**ADDENDUM NO. 01**

**DATE: March 23rd, 2026**

**RE: Jones County Public Works**

Sheet Number: 1 of 5  
Drawing Number: **M-101**

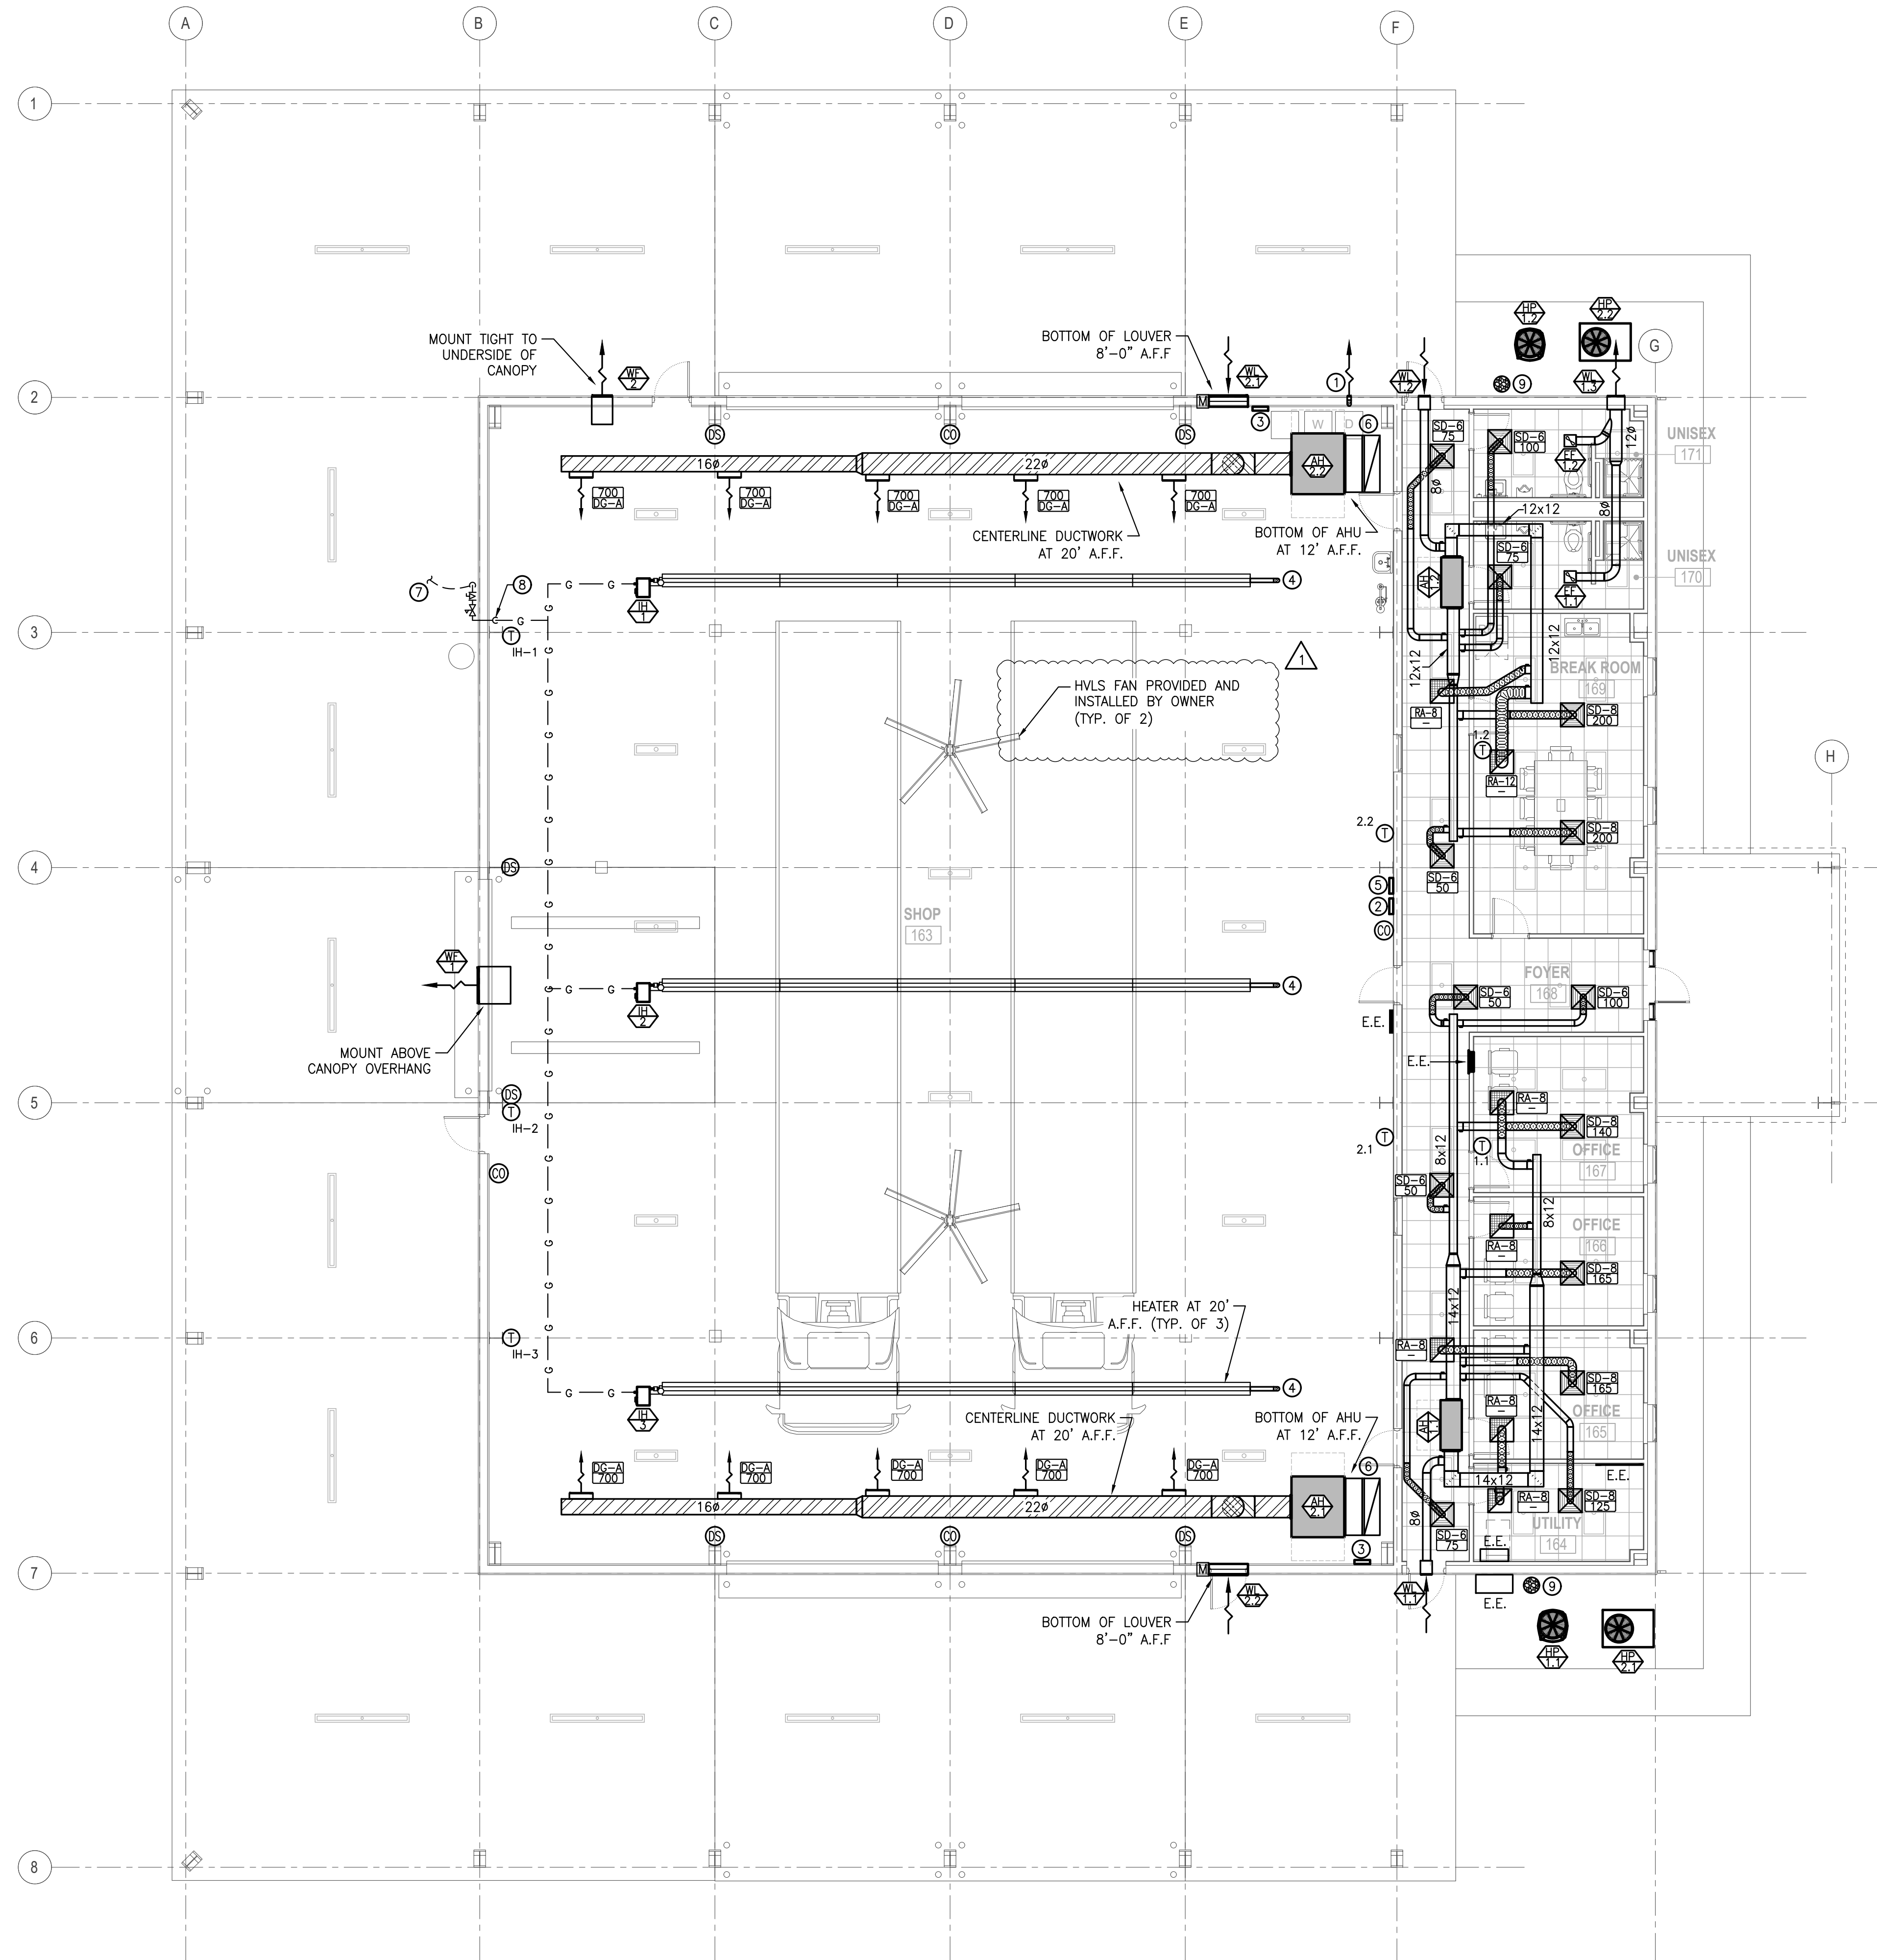
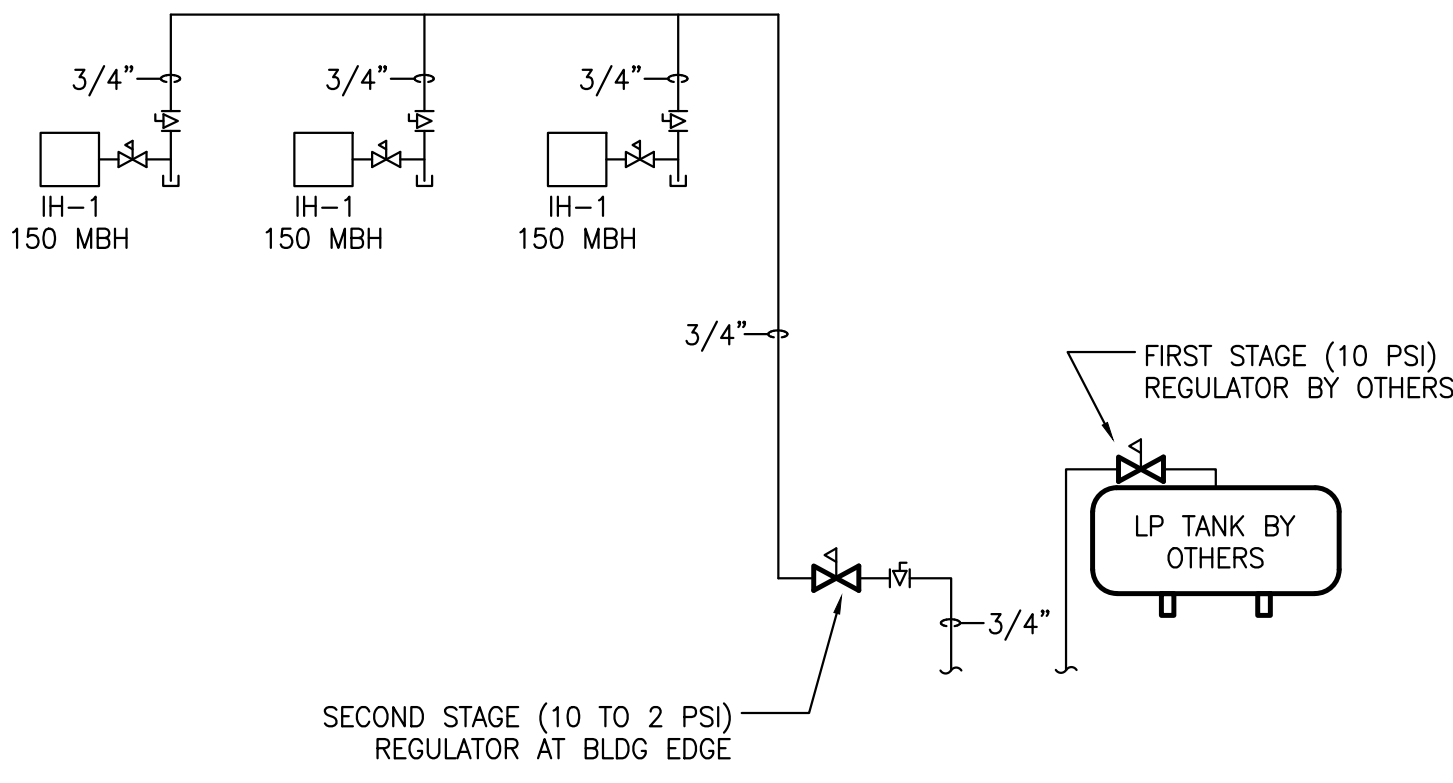
15. Confirm that EC is responsible for CO/Gas detection system conduit and wiring to devices as shown on mechanical plans. If so, please confirm that #14 stranded conductors will be acceptable and please show locations of No2 sensors and any other devices needing raceways. As it stands, there are only 4 CO detectors and the main gas panel shown on M-101. *Response: See Keynote #5 on Drawing E-101.*

16. The LP gas tank location is not shown, will the lp tank vendor be piping the underground gas to the bldg. and supplying the regulators. *Response: High pressure lp gas piping downstream of high-pressure regulator is by M.C.. Tank and high-pressure regulator is by others (LP Provider) as noted in keynote 7 on M-101. Coordinate location of tank with Site/Civil.*

**E-101**

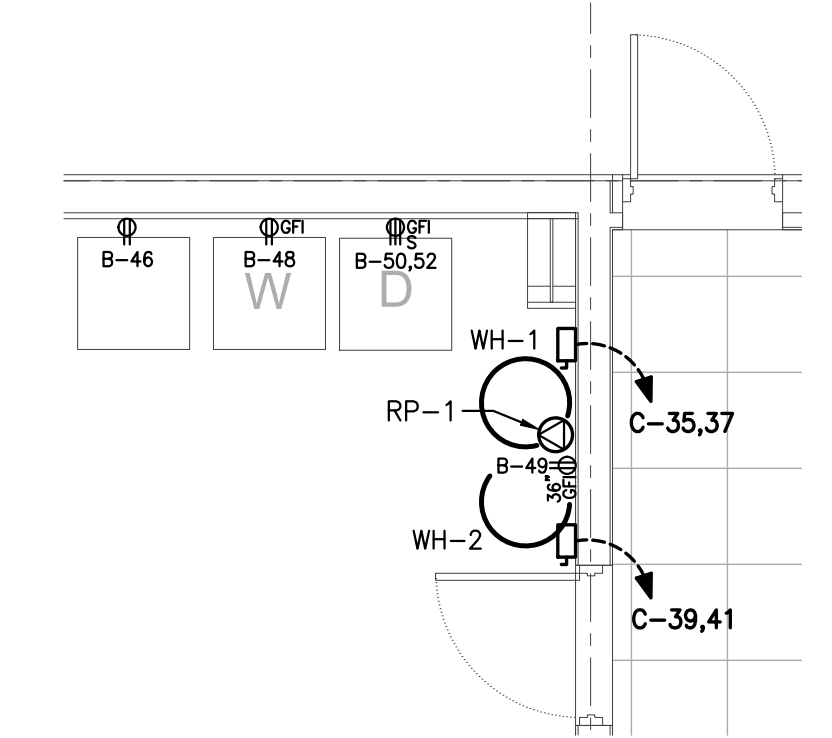
12. Confirm that overhead door provider will be responsible for door controls from motors to controller location and clarify whether or not EC should provide empty raceway to side *Response: The E.C. will provide the raceways and wiring for the controls. Drawings will be revised to reflect this.*

13. Clarify whether or not EC should provide a 30A cord drop with twist lock receptacle for connection to lift. Ref. Ckt B-16,18. *Response: No, the lift is future so please provide switch at roof purlins.*

14. No circuit from building is shown for the sewer lift station. Confirm that no power circuit is required under this contract. If it is, please confirm circuit sizes, lift station location and quantity or circuits as pump circuit and alarm circuit typically are separate from each other. *Response: Please reference revised drawings (Addendum No. 1) for circuits.*

42. I also wanted to confirm EC is responsible for supplying raceways and confirming wiring for the "toxic gas control panel" but who would be providing the panel itself, and the CF-1 VFDs for the (GreenHeck - Fans, which are being supplied by the owner (per the drawings) however it doesn't mention the (VFD) only the fan. *Response: The toxic gas panel is provided by the M.C. and wired by E.C. E.C. is providing only the raceways per key note #3 on E-101*

- PROVIDE 2#14 & 1#14G IN 3/4" C FROM LOUVER TO GAS DETECTION PANEL. PROVIDE DISCONNECT NEXT TO LOUVER MOTOR. 120V POWER FOR LOUVER SHALL COME FROM SAME CIRCUIT AS GAS DETECTION PANEL. GAS DETECTION PANEL HAS A RELAY FOR DAMPER CONTROL. PROVIDE CONTROL WIRING FROM FAN TO GAS DETECTION SYSTEM.

- REFERENCE MECHANICAL DRAWINGS FOR WIRING REQUIREMENTS OF GAS DETECTION SYSTEM. PROVIDE WIRING AND RACEWAYS FOR SENSORS, ALARM STROBE/HORN, AND FAN/DAMPER CONTROL PANEL AND SENSORS. PROVIDED BY M.C..

- PROVIDE CONTROL WIRING AS SUGGESTED BY MANUFACTURER OF OVERHEAD DOOR IN 1/2" CONDUIT TO THE DOOR CONTROLLER. INSTALL DOOR CONTROLLER AT 48" A.F.F. ADJACENT TO THE DOOR. INSTALL THE MOTOR DISCONNECTS EITHER AT 60" A.F.F. OR NEAR THE MOTOR.

- LIFT IS FUTURE. INSTALL DISCONNECT AT CEILING.

**E-301**

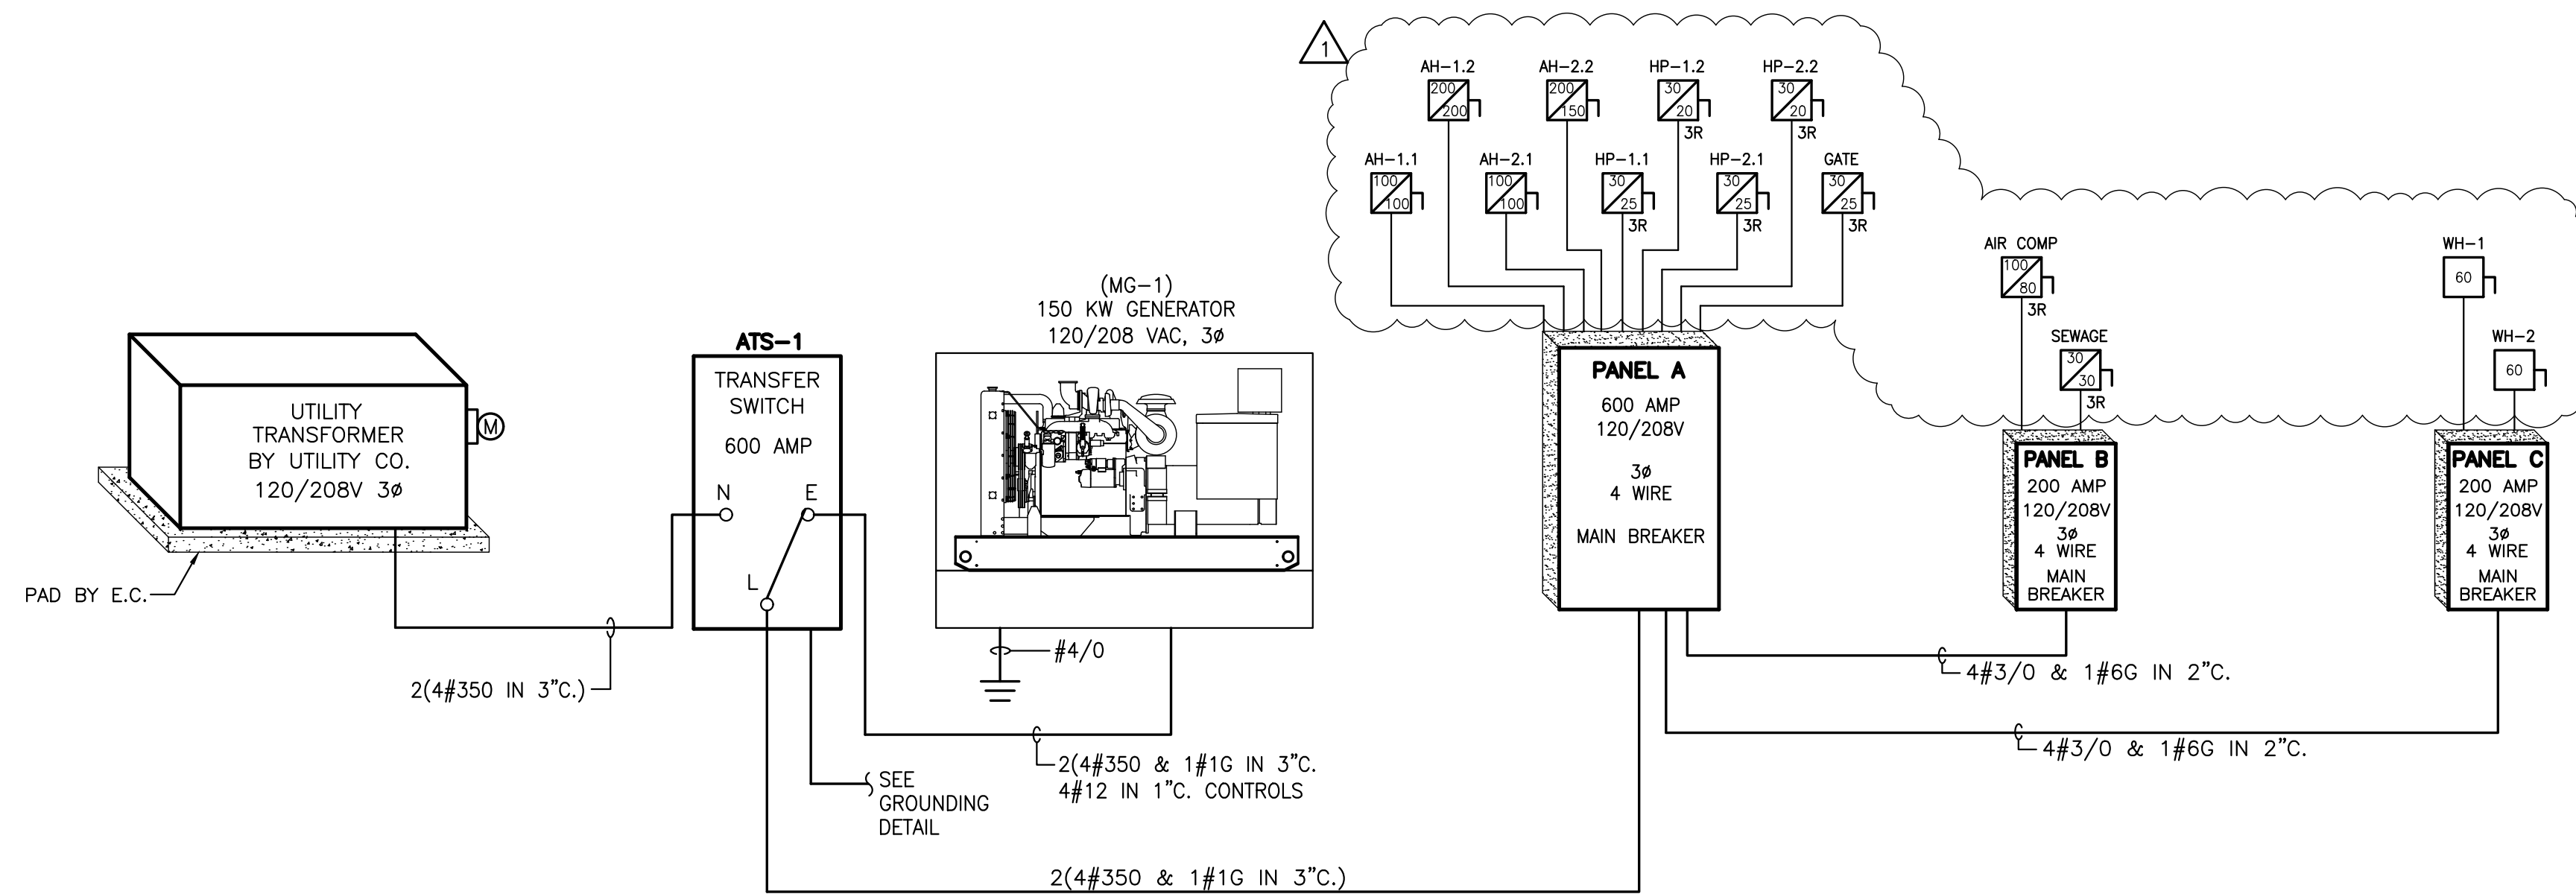
31. The other question I had I noticed on E-301 that the EC is responsible for the transformer pad and that the meter is shown mounted to the transformer and not as part of the building or with a CT cabinet, would that be free standing 3' or further from the utility supplied transformer ? Or is that going to be mounted on the building as I believe the EC would be responsible from the meter to the transfer switch when it comes to underground and utility is responsible from the vault to the transformer in terms of digging, conduit, and wires. *Response: The pad specifications will be per the serving utility's requirements. It is believed that Duke Energy is the utility service provider. The CT's and meter will be on the transformer. Drawing E-301 shows what conductors and raceways are required.*

**E-302**

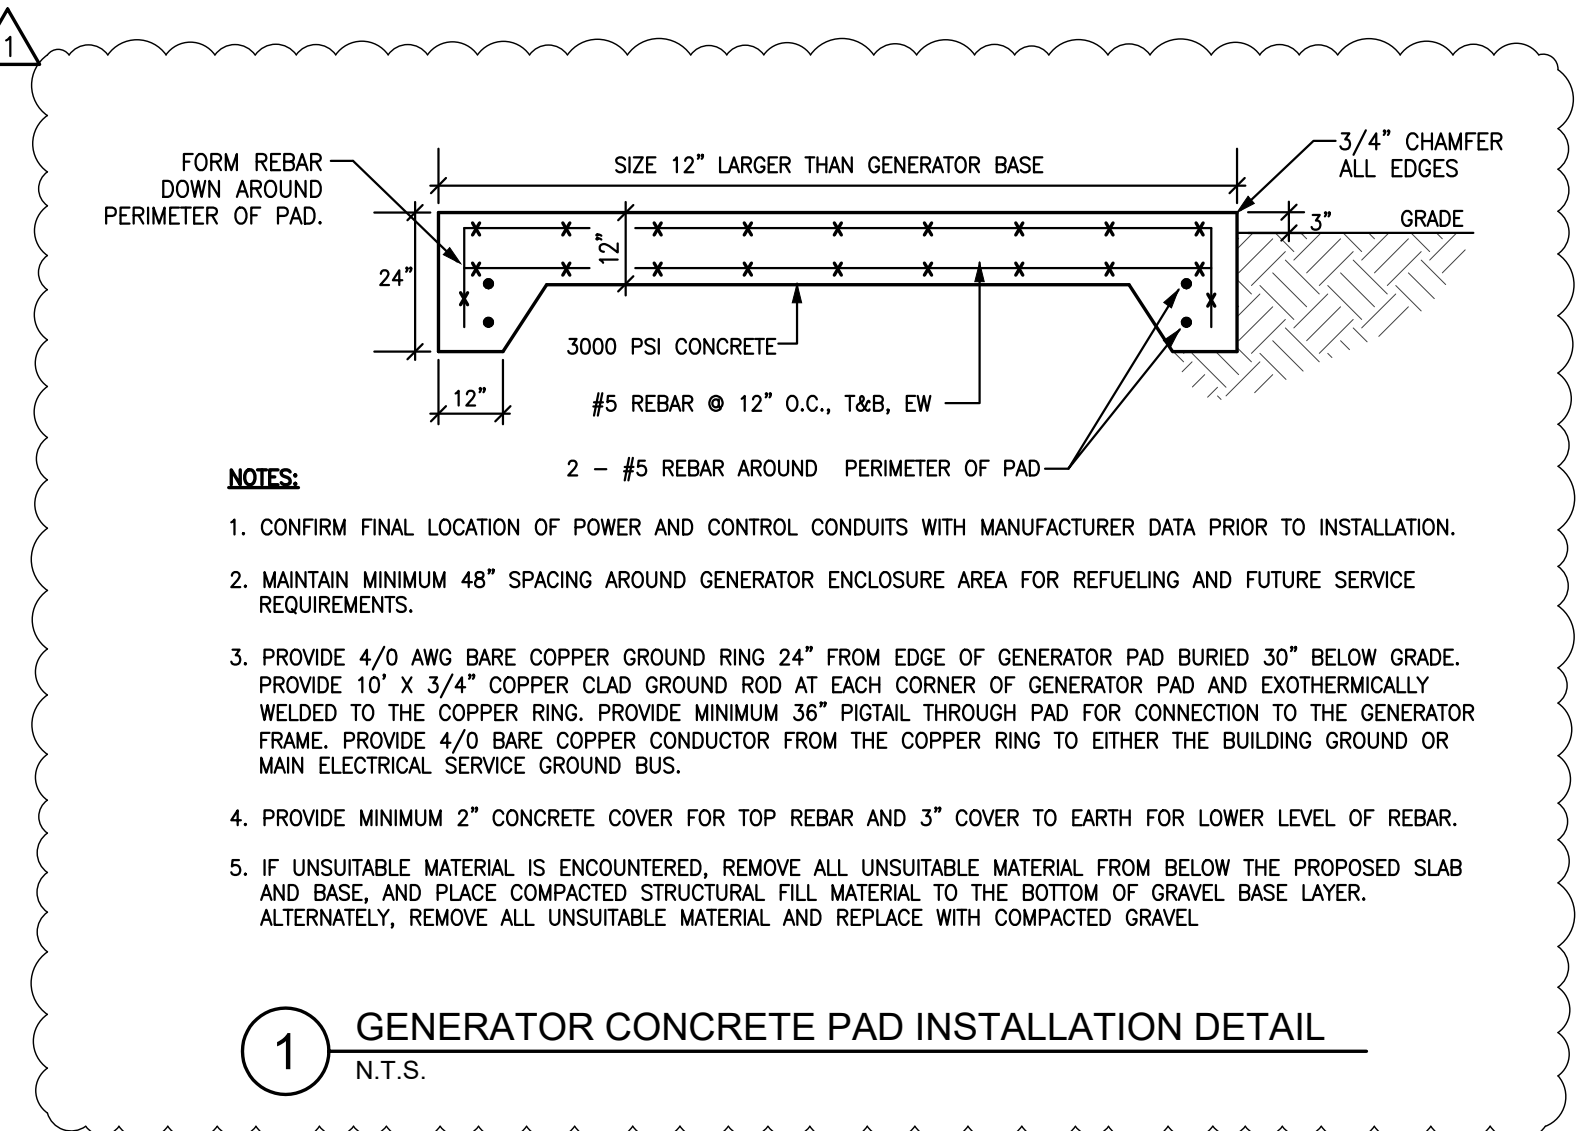
32. Lastly is there any specs on the concrete pad that are required for either the transformer pad or the generator ? I didn't see any on the S201 section of the drawings. *Response: Please see revised drawing E-302 for generator pad. Transformer pad will meet serving utility requirements.*
